NL-08-0300

**Vogtle Electric Generating Plant  
Response to NRC Request for Additional Information Regarding License  
Amendment Request to Revise Technical Specifications (TS) 3.3.2, "ESFAS  
Instrumentation," and TS 3.5.4, "Refueling Water Storage Tank (RWST)"**

**Response to NRC Request for Additional Information**

**Vogtle RWST Methodology**

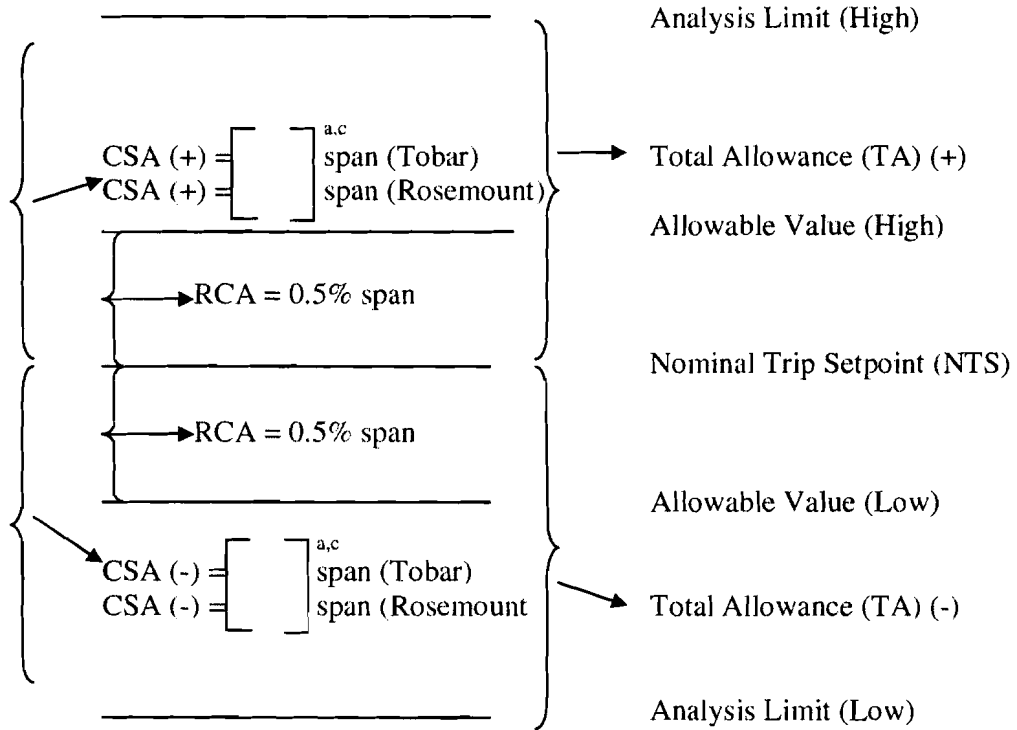
**Discuss the methodology used to determine the overall instrument uncertainty for the RWST Level Low-Low trip function.**

The basic uncertainty algorithm used to determine the overall instrument uncertainty for the RWST Level Low Low trip function is the square-root-sum-of-the squares (SRSS) of the applicable uncertainty terms. This is the same methodology as defined in WCAP-11269, Revision 1, "Westinghouse Setpoint Methodology for Protection Systems Vogtle Station," as modified for term dependencies as shown on the attached tables. This methodology combines the uncertainty components for a channel in an appropriate combination of those groups which are statistically and functionally independent. Those uncertainties which are not independent are conservatively treated by arithmetic summation and then combined via SRSS with the independent terms. This approach is consistent with NRC Regulatory Guide 1.105, Revision 3, "Setpoints for Safety-Related Instrumentation," and ISA Standard 67.04.01-2006, "Setpoints for Nuclear Safety-Related Instrumentation."

A calculation determined the bounding Channel Statistical Allowance (CSA) for this function. The Allowable Values (AVs) are determined by adding (or subtracting) the calibration accuracy, defined by the Rack Calibration Accuracy (RCA), to the Nominal Trip Setpoint (NTS) in the non-conservative direction(s) (i.e., toward or closer to the Analysis Limit(s) (AL)) for the application. The magnitude of the as left (calibration accuracy term) and the as found tolerances are the same and are specified in the station procedures.
